## CITY OF MARLBOROUGH MEETING POSTING

Meeting: **Planning Board**  
Date: **December 21, 2020**  
Time: **7:00 PM**  
Location: **REMOTE MEETING NOTICE**

Subject: Four-Lot Subdivision, 76 Broad Street, Marlborough, MA  
**Response to Engineering Division review comments**

DEFINITIVE SUBDIVISION PLAN

TITLE  
SHEET

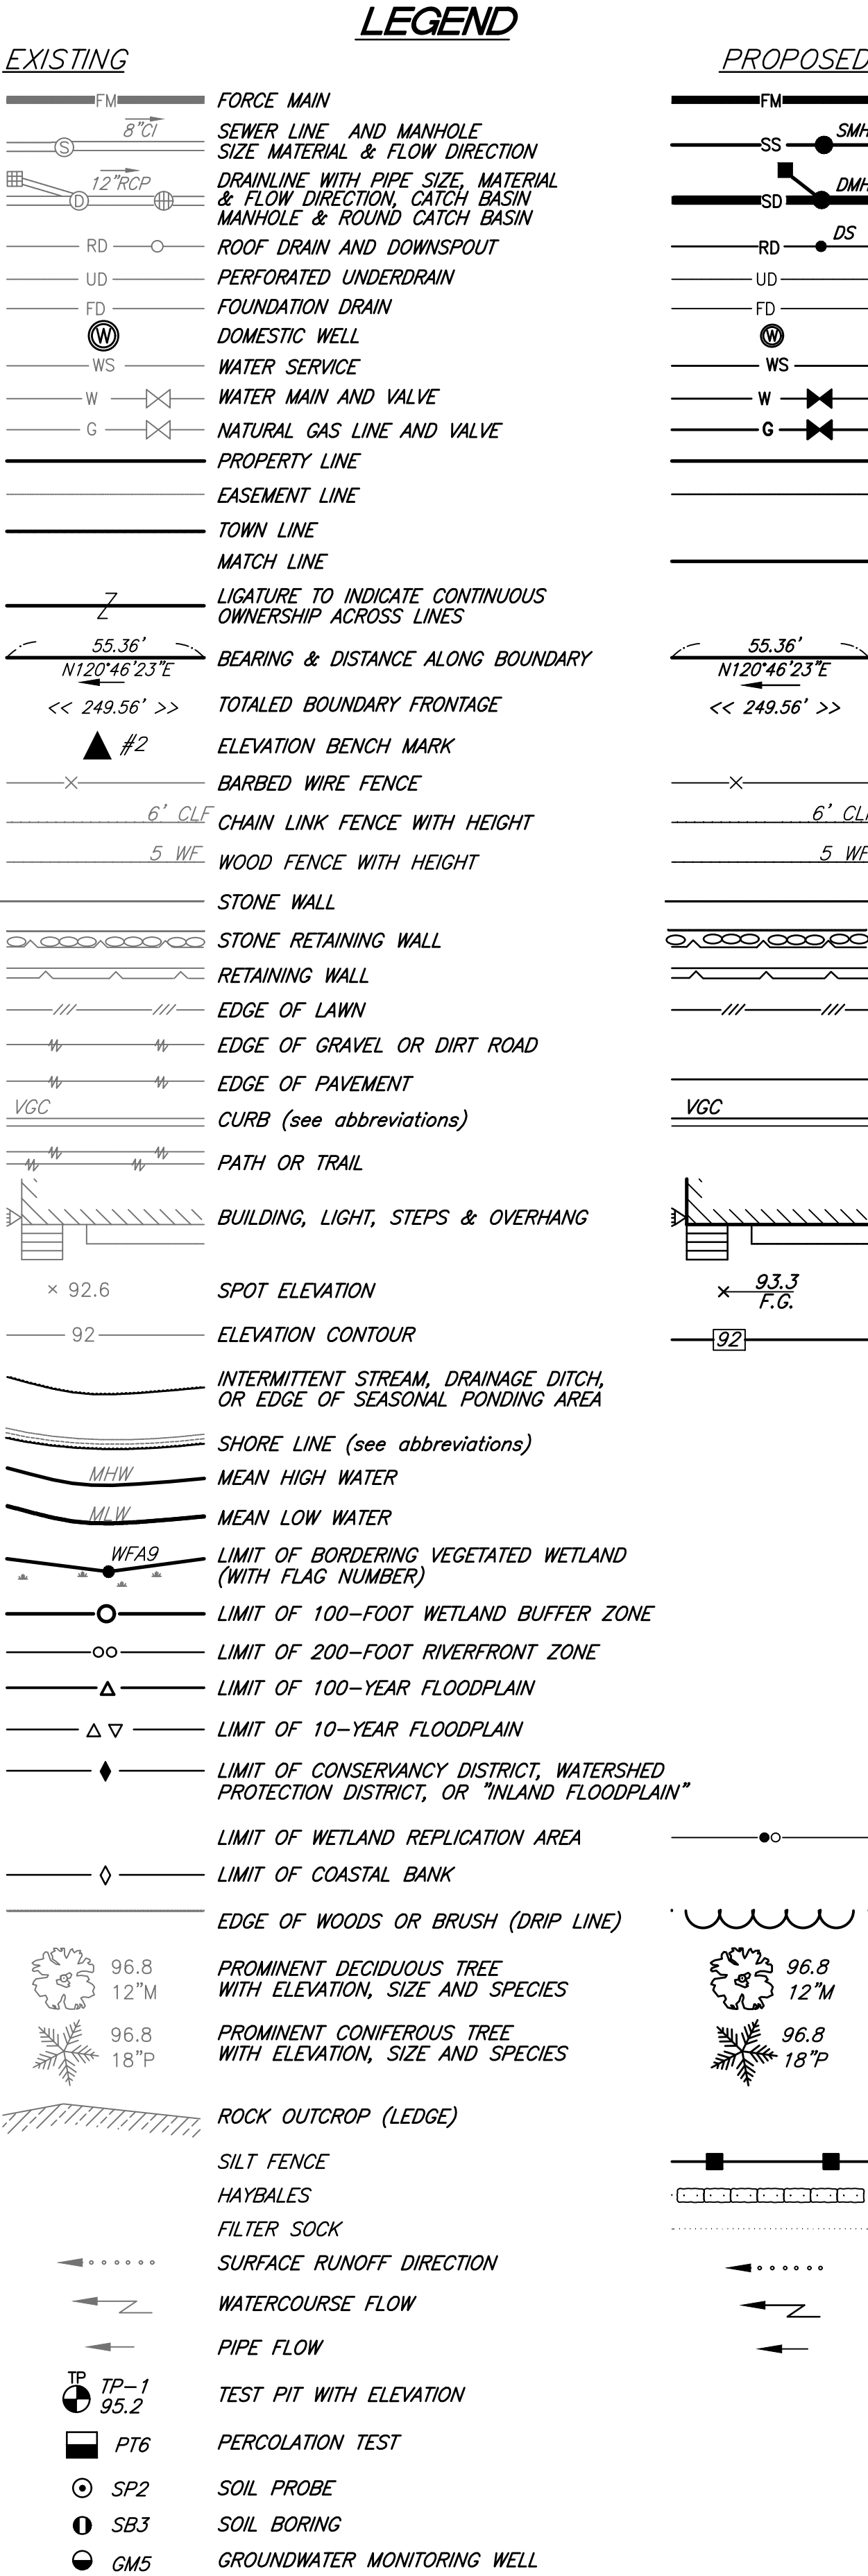
- "Planning" is misspelled in the plan references section.

**Response: The Title Sheet (C1) has been revised.**

# EXISTING CONDITIONS PLAN

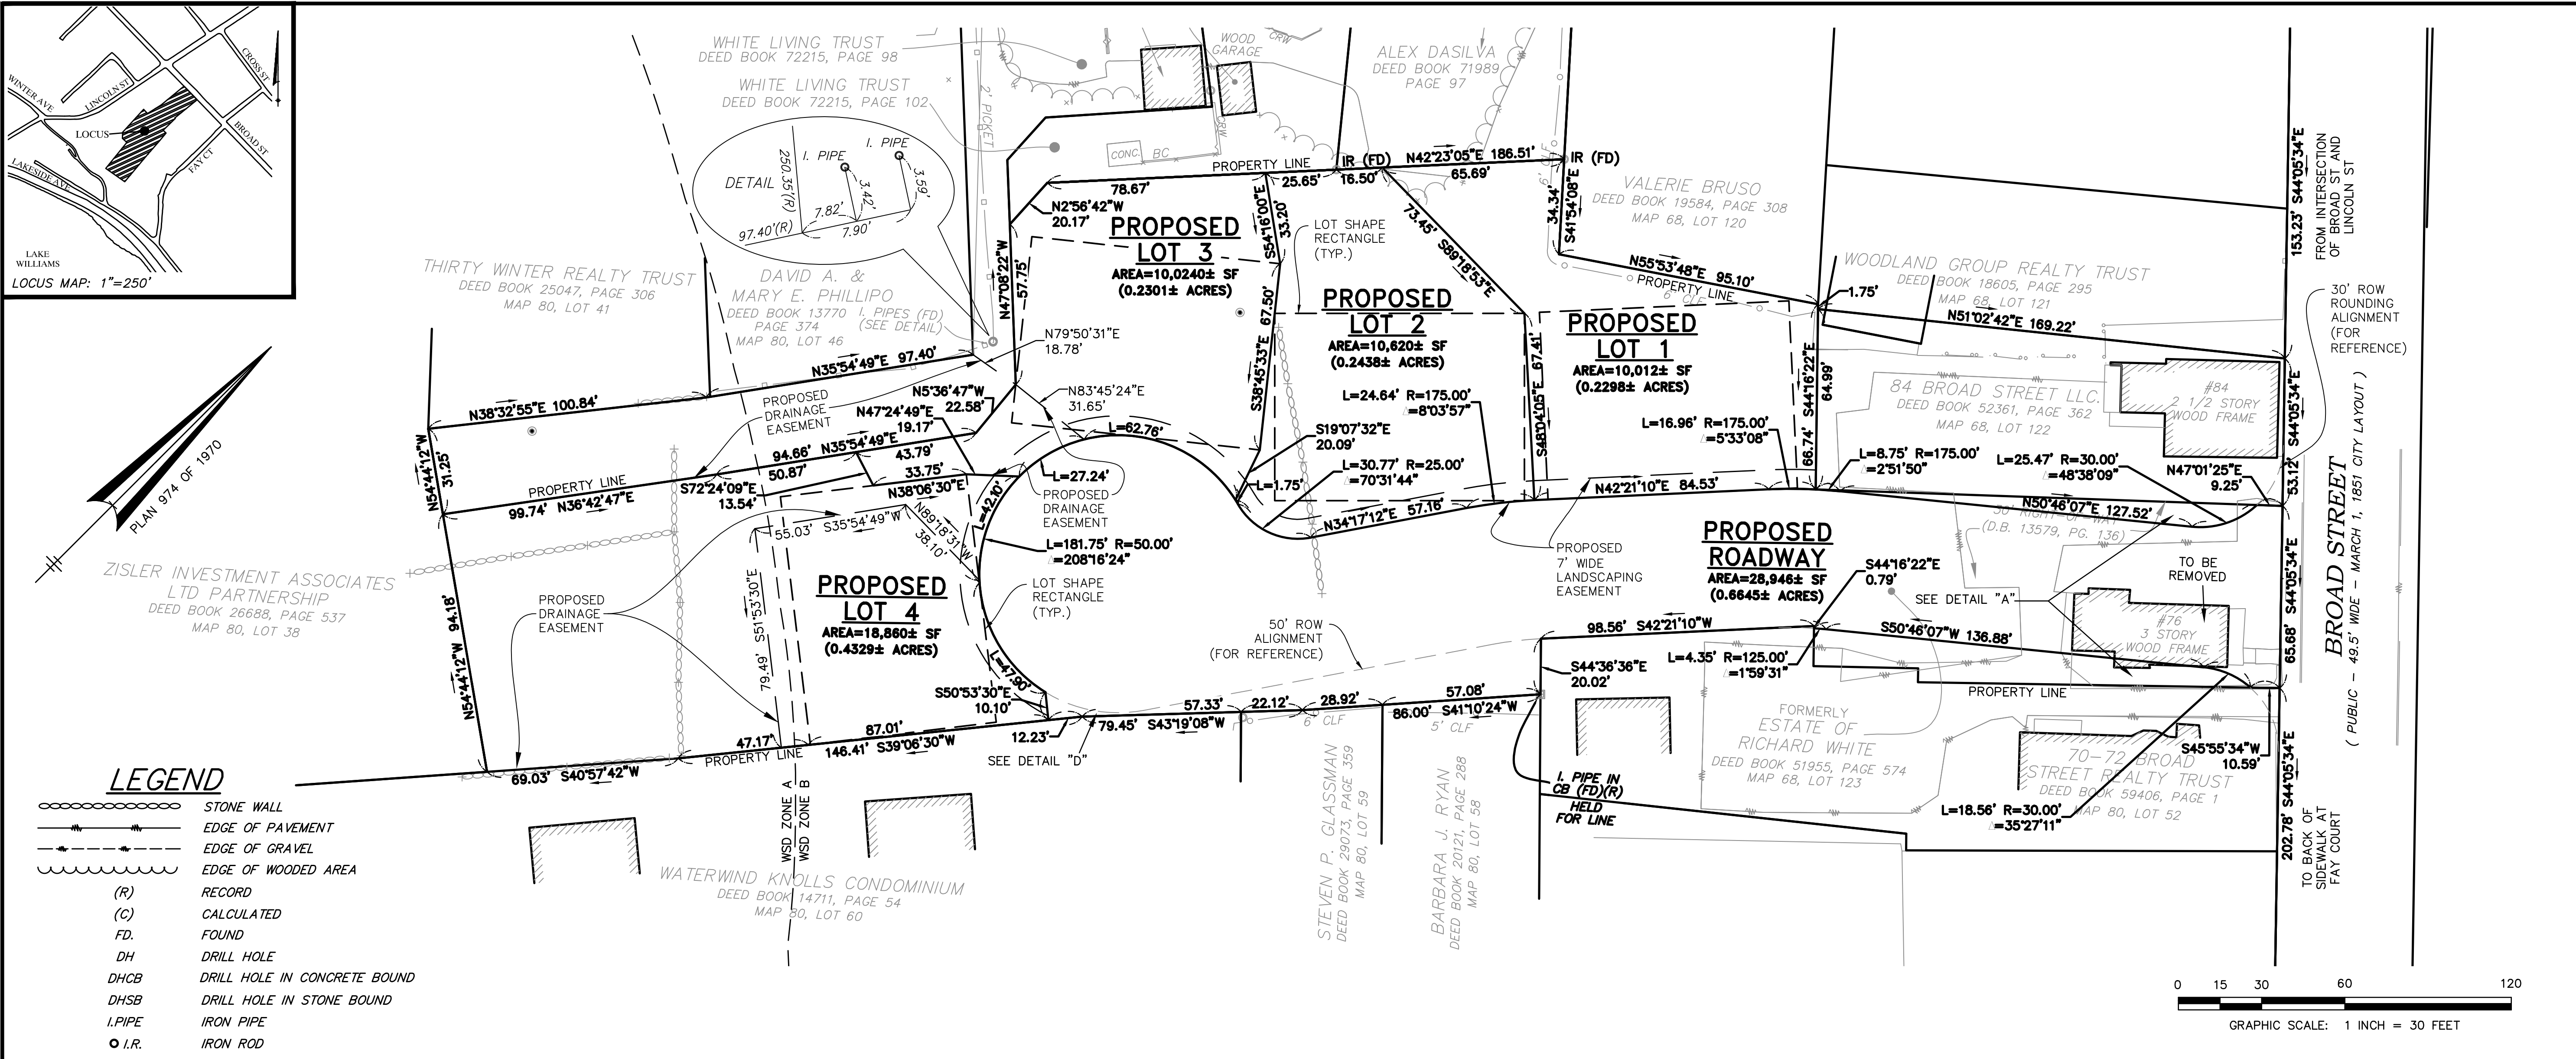
- Remove the metes and bounds, the lot designations and the areas for Lots 1, 2, and 3 and replace their identifying information with Registry Book & Page and Assessor's Map & Parcel.

- The dimensions shown in the Detail view of the iron pipes found near the eastern corner of the Phillipo property shown on this sheet are different than the dimensions shown on the Lotting Plan.

- This plan shows "Lots 1, 2, and 3" off of Lincoln Street, will be changing in area. However the Lotting Plan is not clear where the changes in lot lines will occur. It is also confusing that these lots are numbered 1-3, and there are new "Lots 1-3" on the Lotting Plan.

- If these lots are not changing as part of this plan, then remove the metes and bounds, the lot designations and the areas for them, and replace their identifying information with Registry Book & Page and Assessor's Map & Parcel.

**Response: The Existing Conditions Plan (EC) has been revised.**

**Response: This discrepancy between these sheets (EC & DS) has been corrected.**

**Response: The Existing Conditions Plan (EC) has been revised to correctly depict Lots 1, 2, and 3 off Lincoln Street as existing lots.**

**Response: The Existing Conditions Plan (EC) has been revised.**

# Lotting Plan

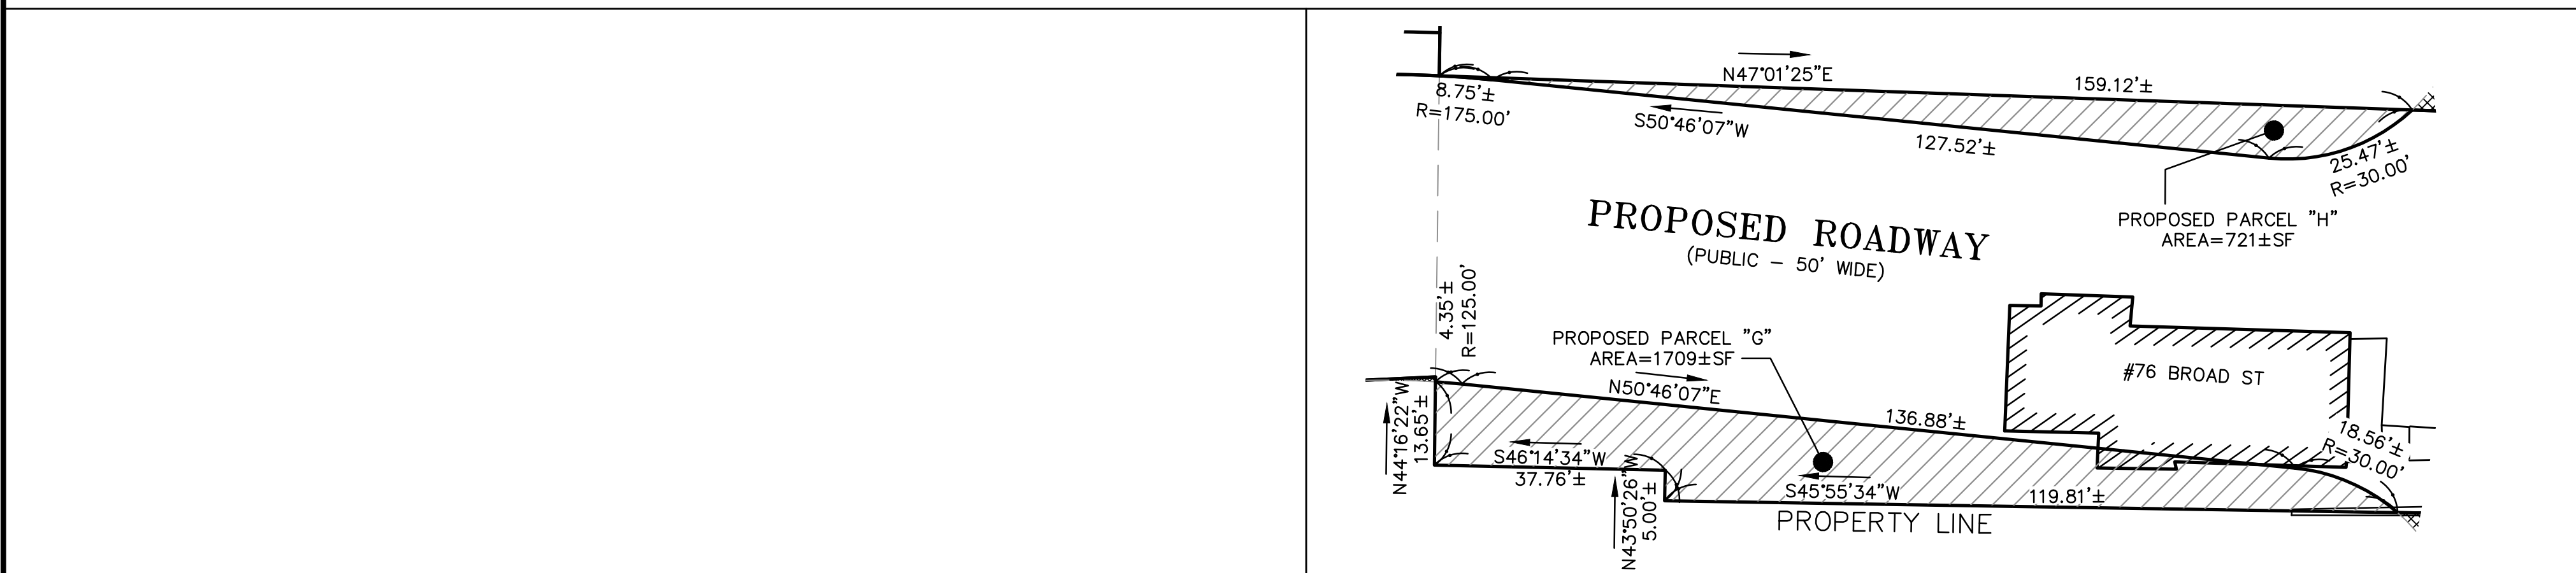
- Remove the text "6 FT SIDEWALK" from the proposed roadway

- This sheet should contain a note stating that "Parcels D, E, F, G, H" are not to be considered separate building lots, and indicate the disposition of said parcels. The Layout and Materials Plan states that the parcels are to be deeded to the abutters.

- The dimensions shown in the Detail view of the iron pipes found near the eastern corner of the Phillipo property shown on this sheet are different than the dimensions shown on the Existing Conditions Sheet.

**Response: The Lotting Plan (DS) has been revised.**

**Response: A note has been added to the Lotting Plan (DS).**

**Response: This discrepancy between these sheets (EC & DS) has been corrected.**

LAYOUT: UT

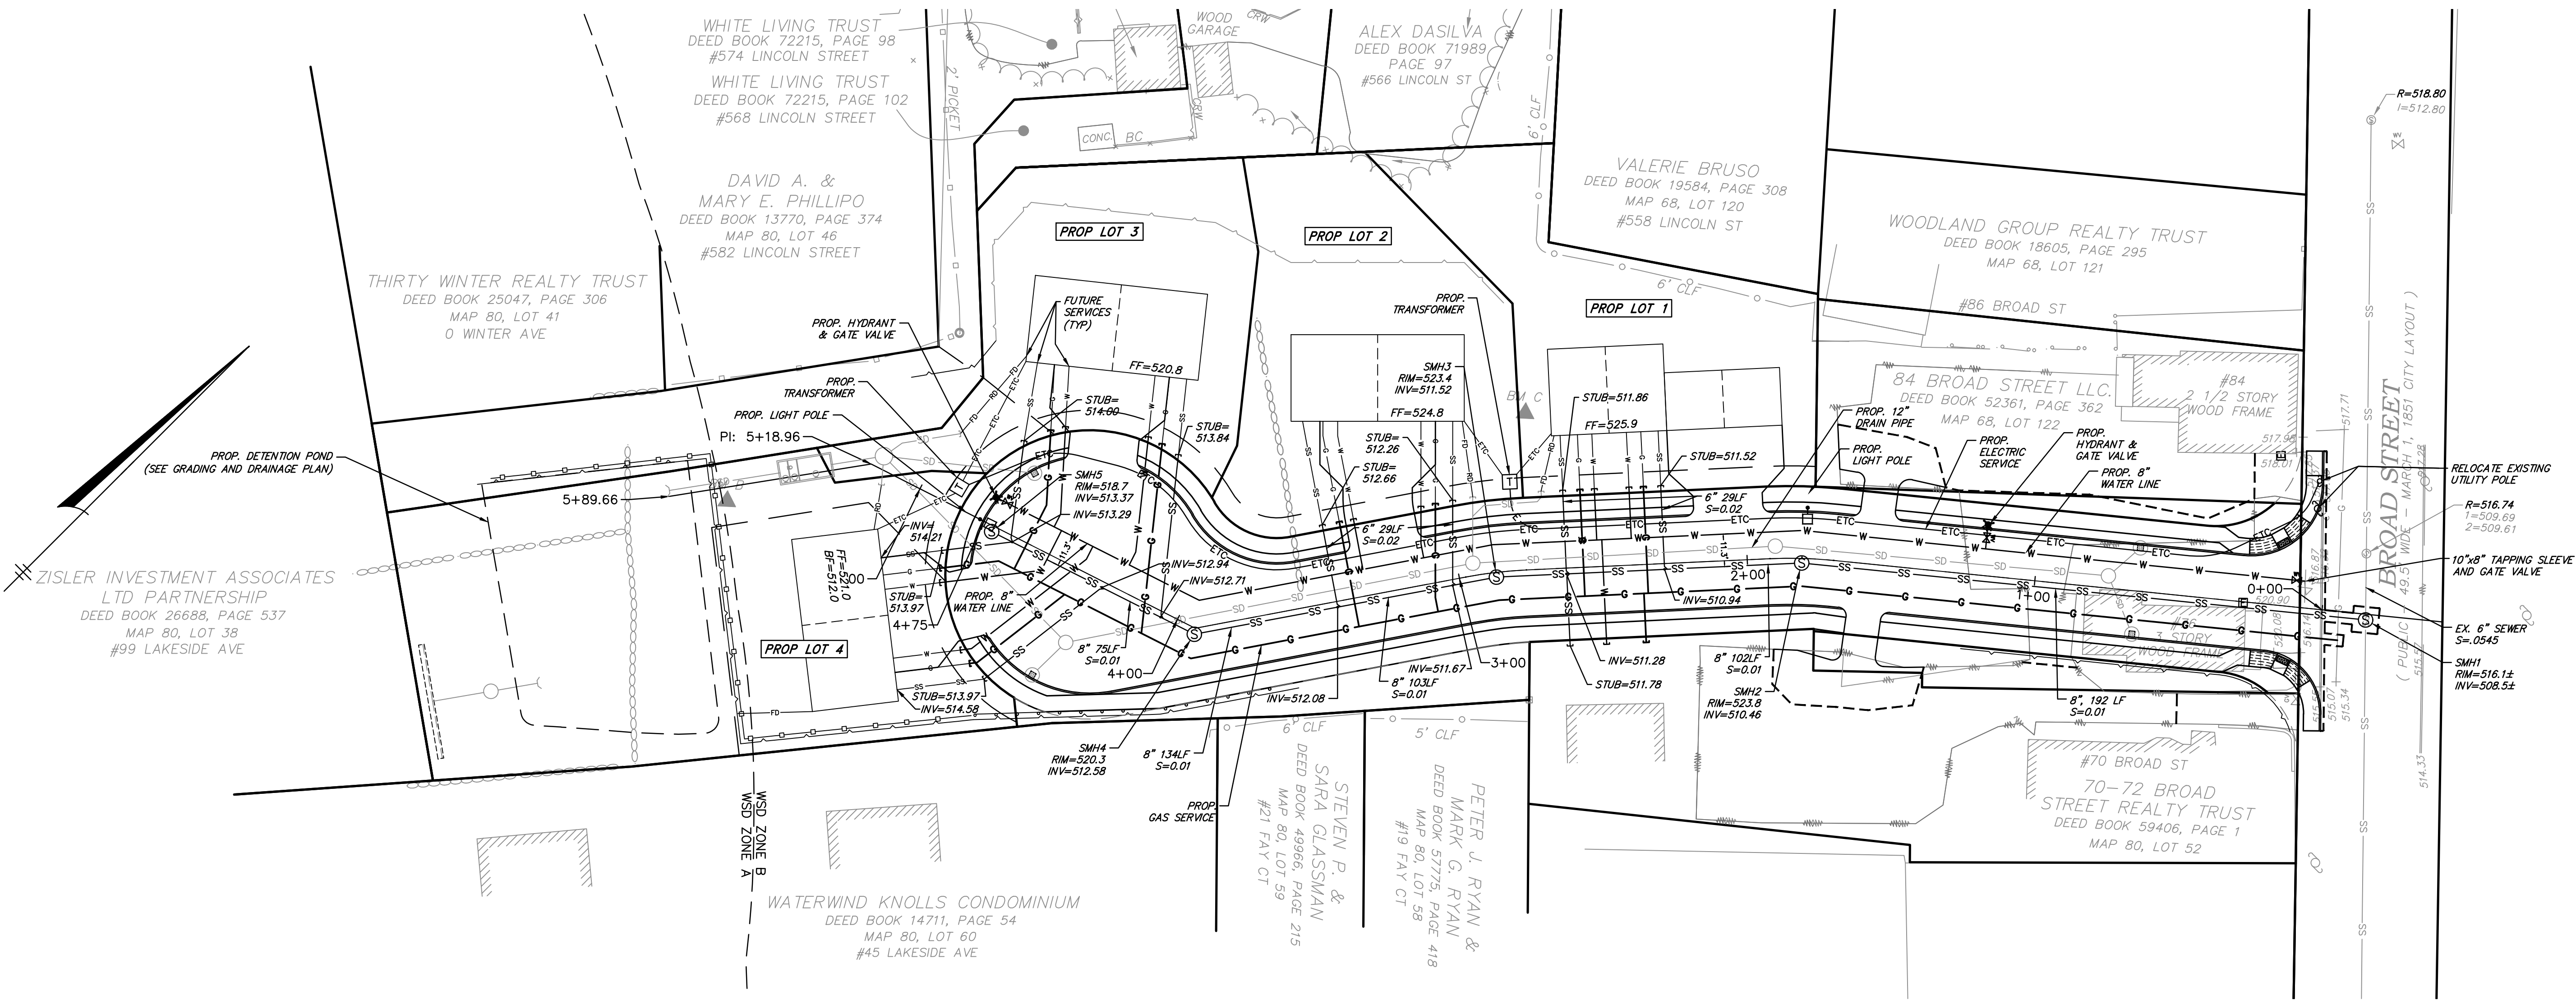
- The Utility Plan should show the baseline for the road for easier interpretation of the Plan & Profile Plan.

- A hydrant should be added to the end of the cul-de-sac for water main flushing. The proposed hydrant should be relocated to the other side of the crest in the roadway, at the same elevation as proposed.

**Response: The Utility Plan (C7) has been revised.**

**Response: The Utility Plan (C7) and the Plan and Profile (C8) have been revised.**
